Product Change Notification

Change Notification #: 117467 - 00
Change Title: Intel® RAID Maintenance Free Backup
AXXRMFBU4,
PCN 117467-00, Product Design,
Order Code,
Updates made to firmware, connectors,
cable and mounting bracket
Date of Publication: March 5, 2020

Figure1. Connector and cable change

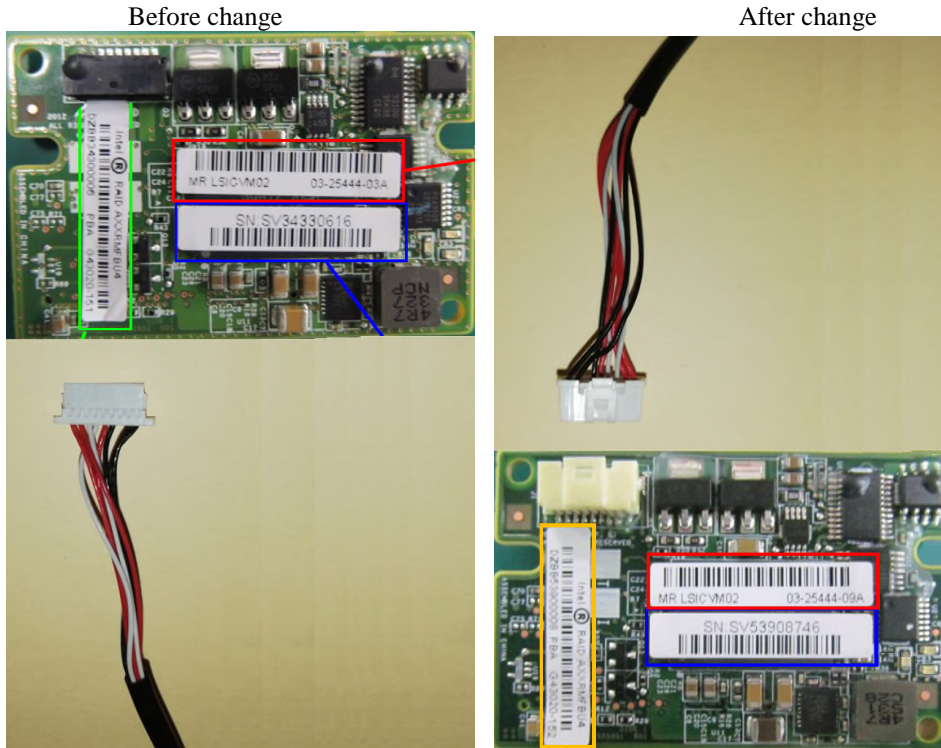
1. Update microcontroller firmware.
2. Update Supercap version to v15.
3. Change connector type on PCB.
4. Change cables to match connector type on PCB.
5. Change the retention bracket to improve attachment, now it includes a separate locking tab.

See figures 1 and 2 on the next page to better understand the changes on the connectors, cable and mounting bracket.
